Wisconsin Department of Transportation

Proposal #18: 2430-06-70, WISC 2017 164
Colony Avenue
7th Avenue to STH 20
USH 45
Racine County

This is Addendum No. 01, which provides for the following:

ADDENDUM NO. 01

Addendum No. 01
 ID 2430-06-70
 Added Sheet 35A
 March 31, 2017

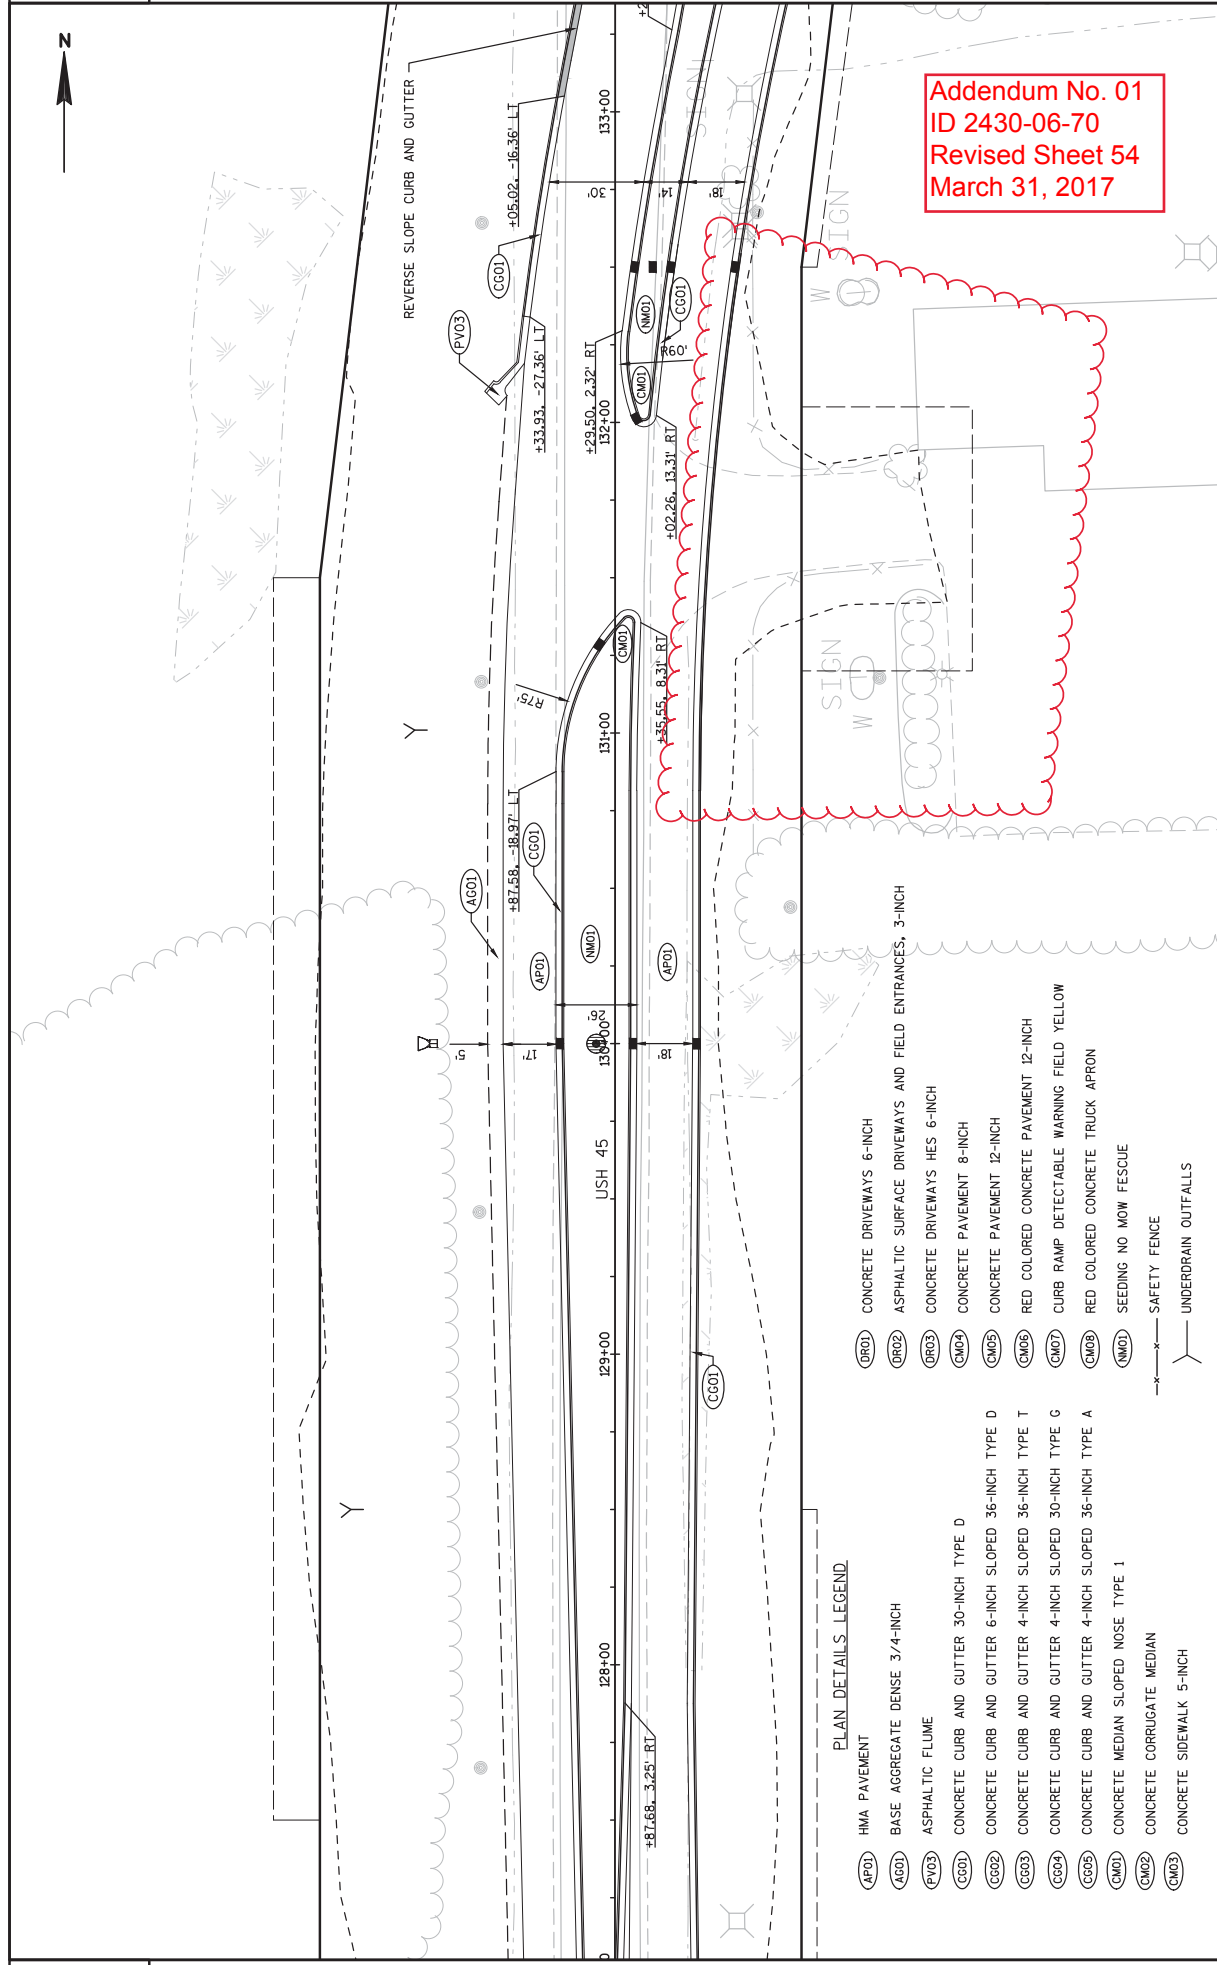
| Added Plan Sheets | |
|--------------------------|--|
| 35A | Construction Detail – Driveway From CTH C (additional driveway reconstruction) |

Addendum No. 01
 ID 2430-06-70
 Revised Sheet 54
 March 31, 2017

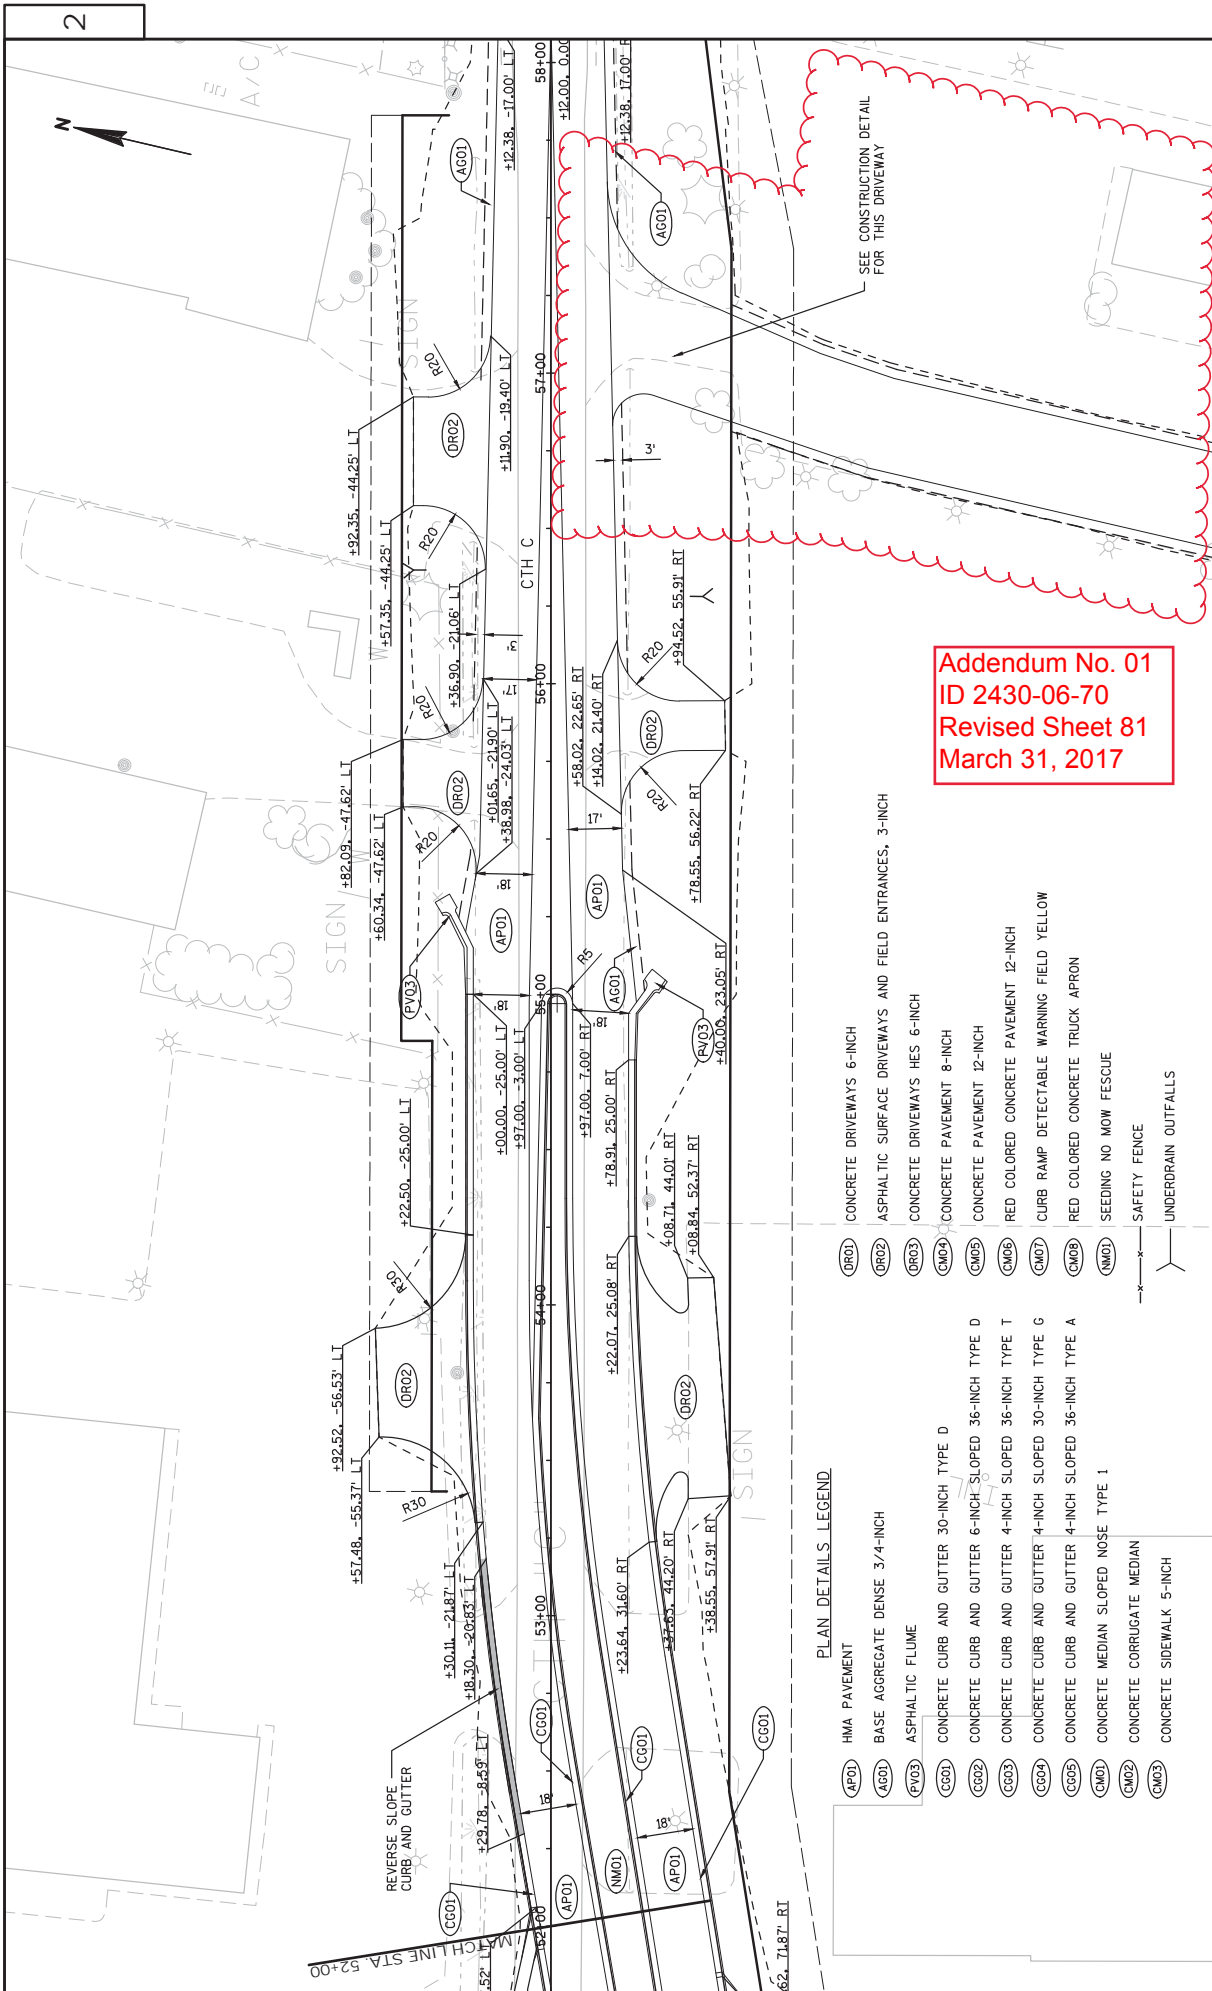
| Revised Plan Sheets | |
|---------------------|--|
| 54 | Plan Detail (removed proposed driveway) |

Addendum No. 01
 ID 2430-06-70
 Revised Sheet 127
 March 31, 2017

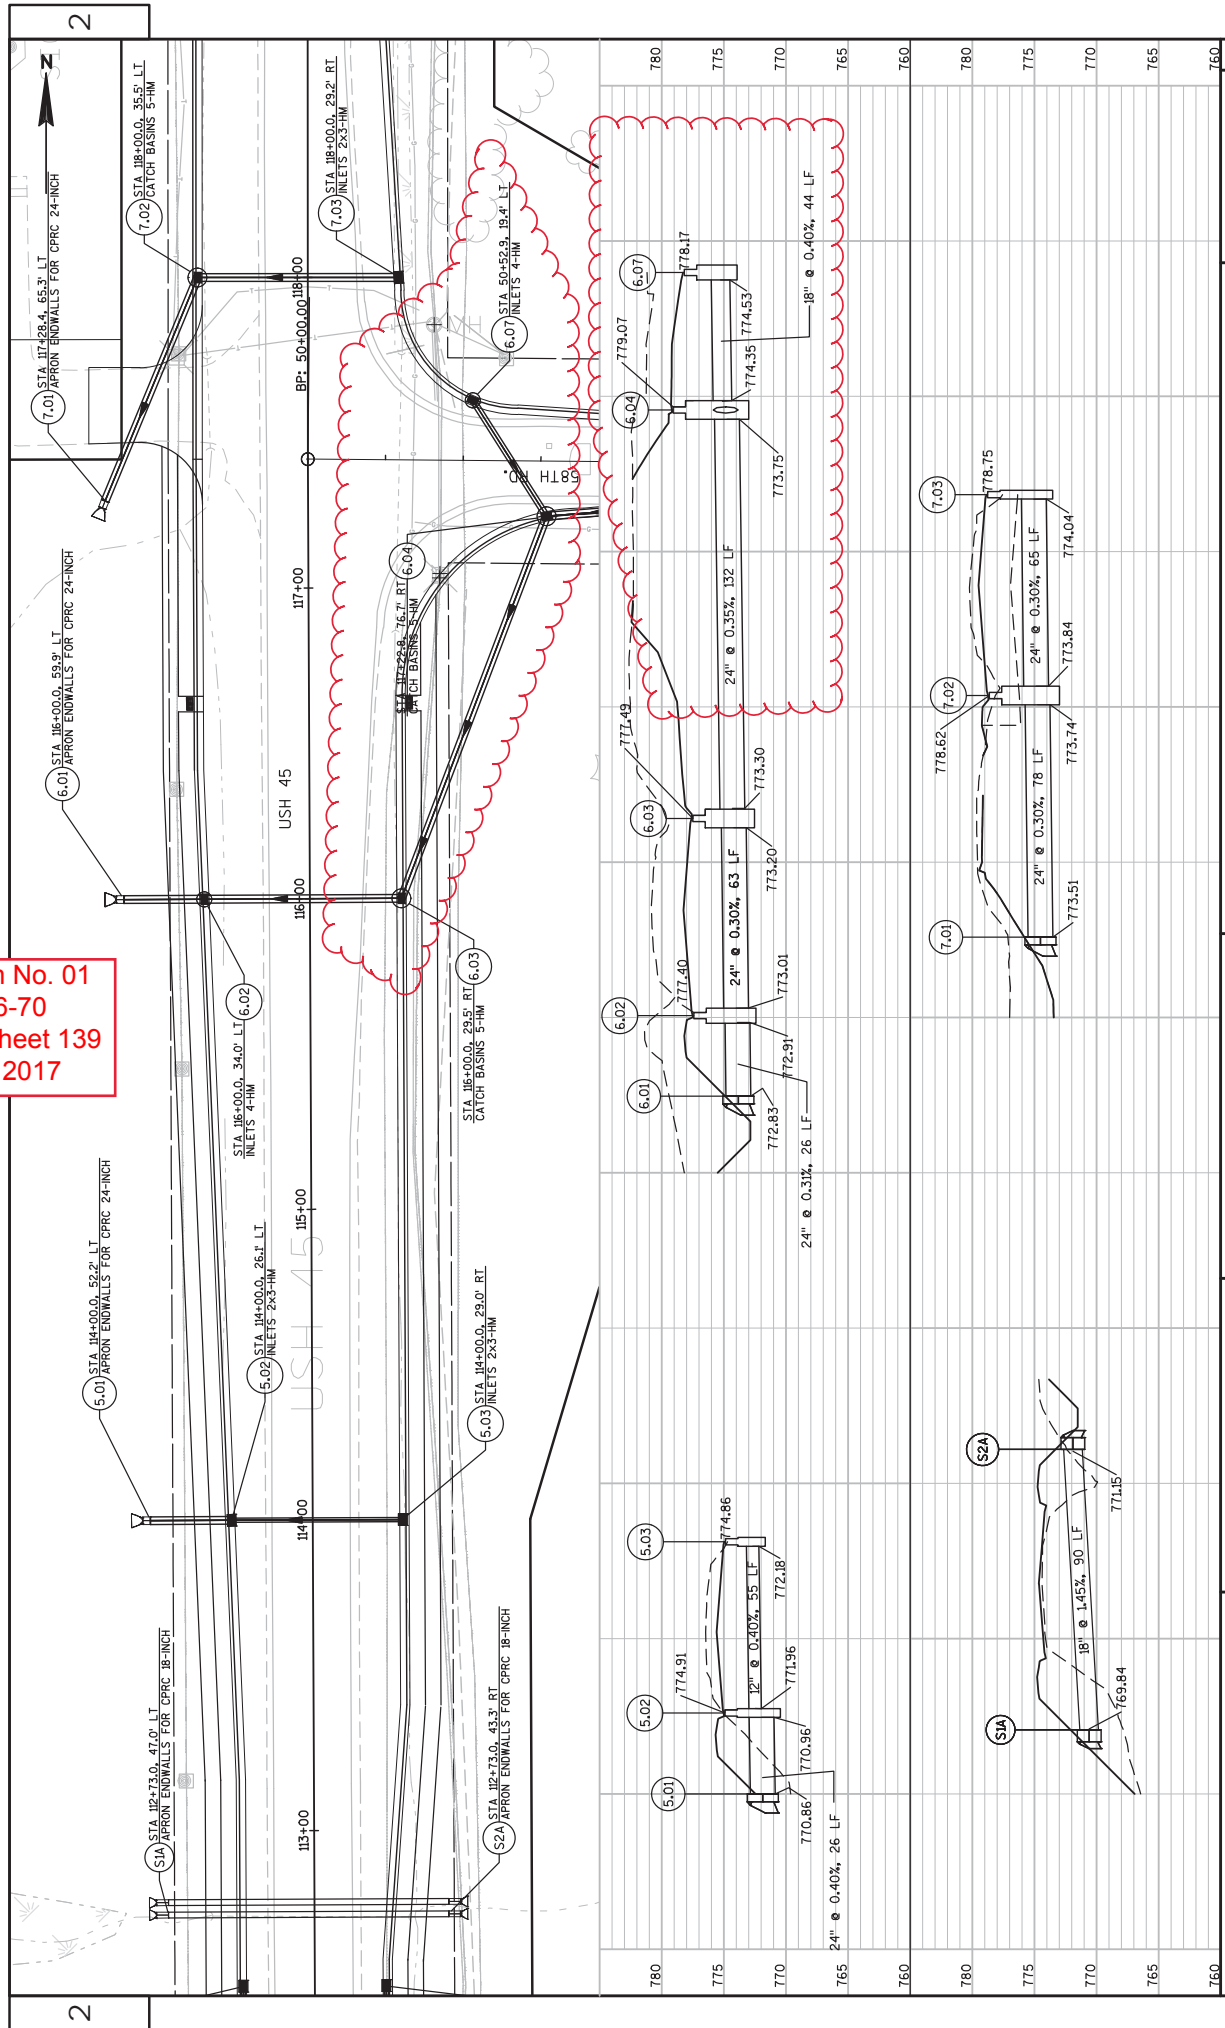
| Revised Plan Sheets | |
|---------------------|--|
| 127 | Erosion Control (removed proposed driveway) |

Addendum No. 01
 ID 2430-06-70
 Revised Sheet 139
 March 31, 2017

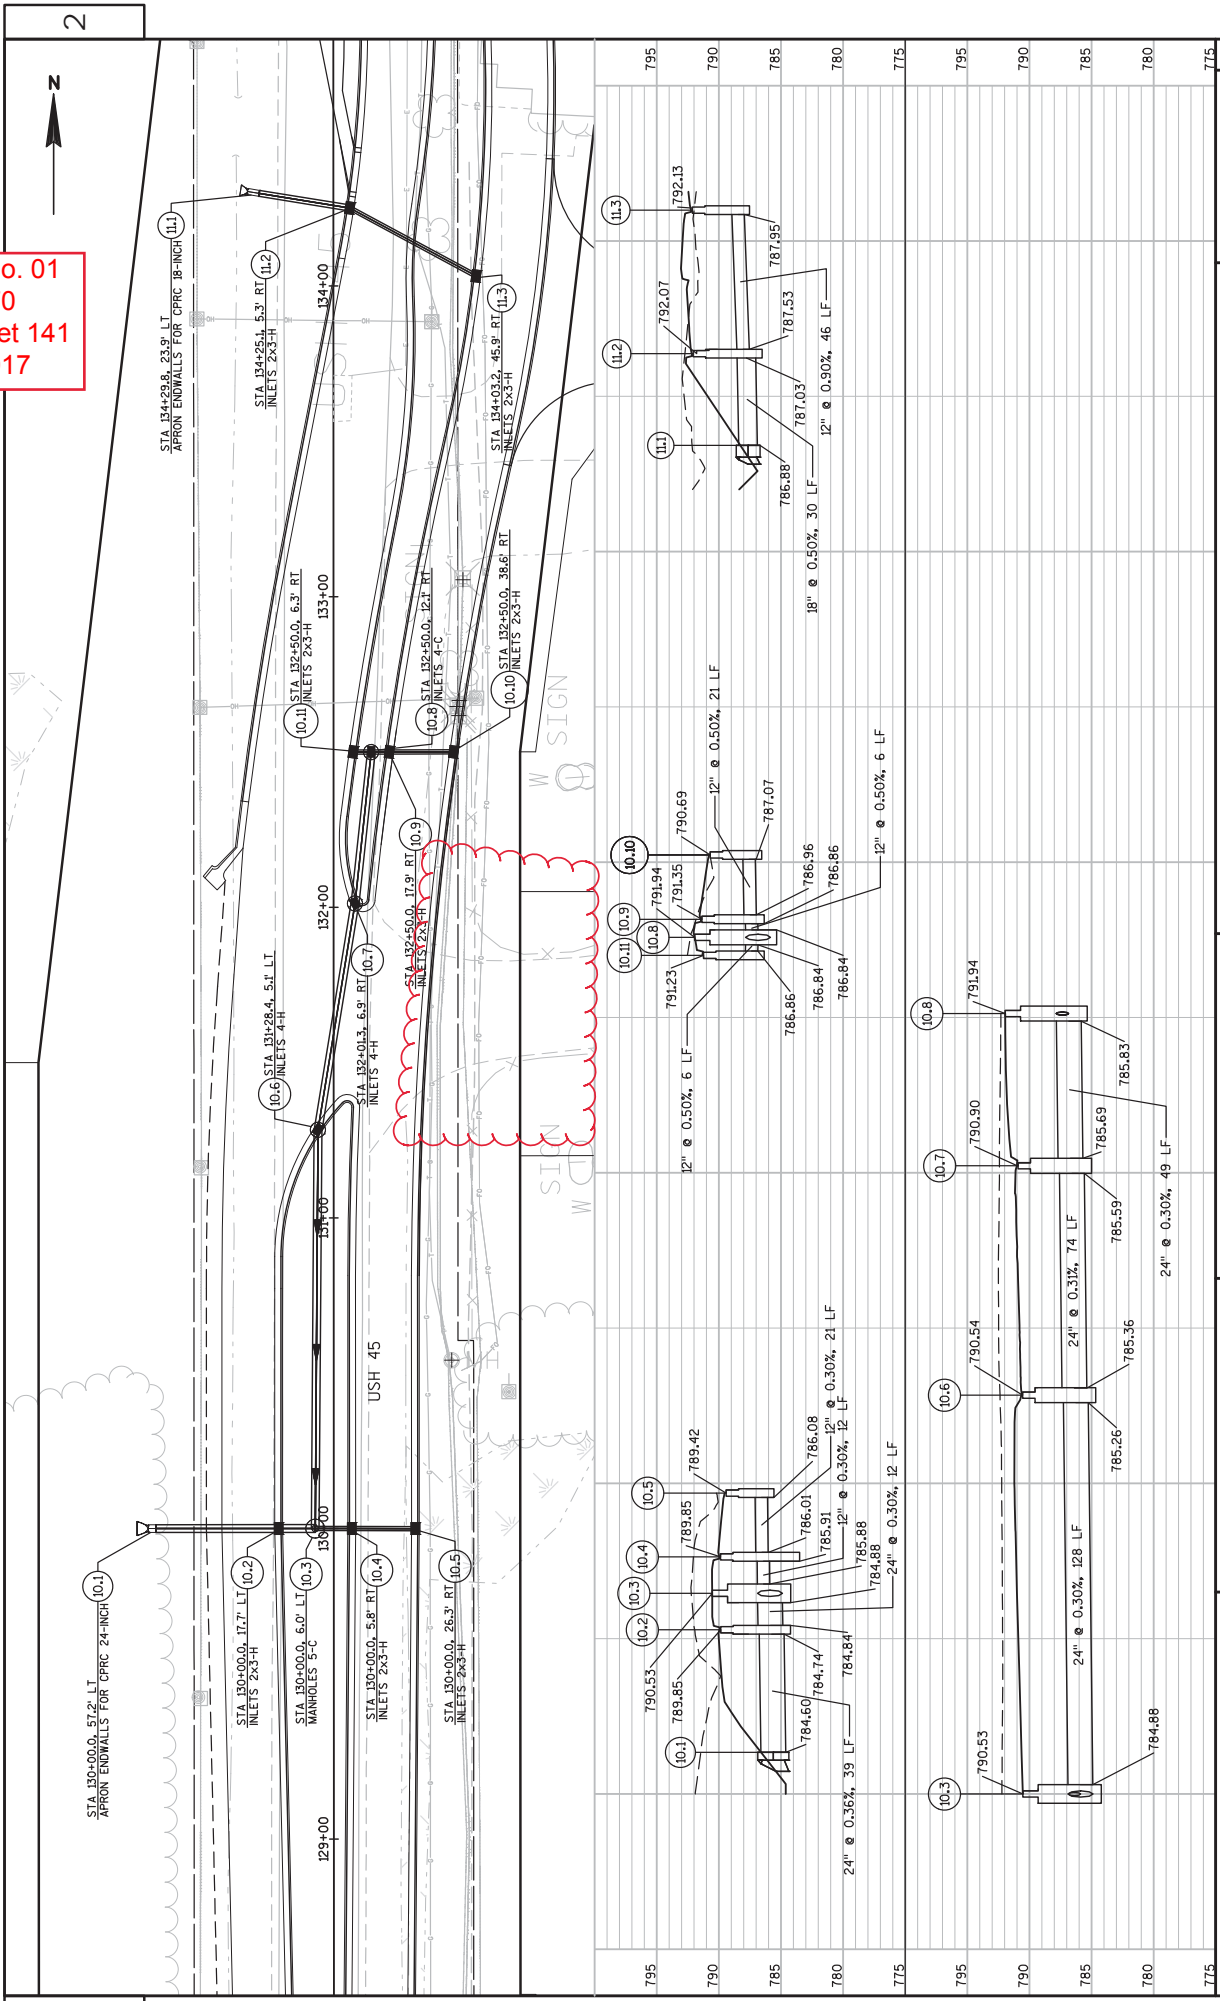
| Revised Plan Sheets | |
|---------------------|--|
| 139 | Storm Sewer (revised storm sewer profile and plan for pipe run 6.03 to 6.07) |

Addendum No. 01
ID 2430-06-70
Revised Sheet 289
March 31, 2017

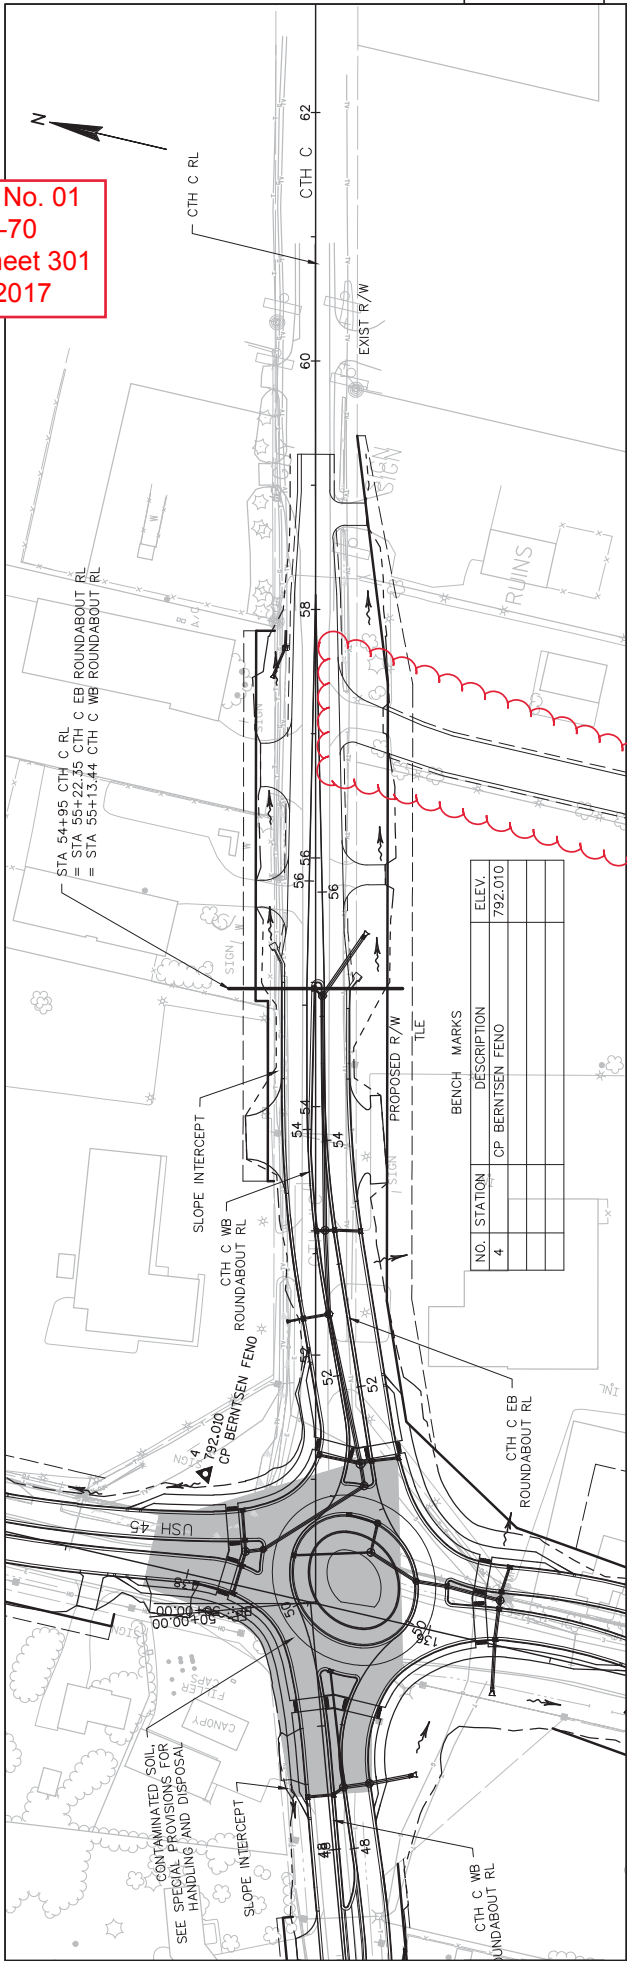
| Revised Plan Sheets | |
|---------------------|--|
| 289 | Plan and Profile: USH 45 (removed proposed driveway) |
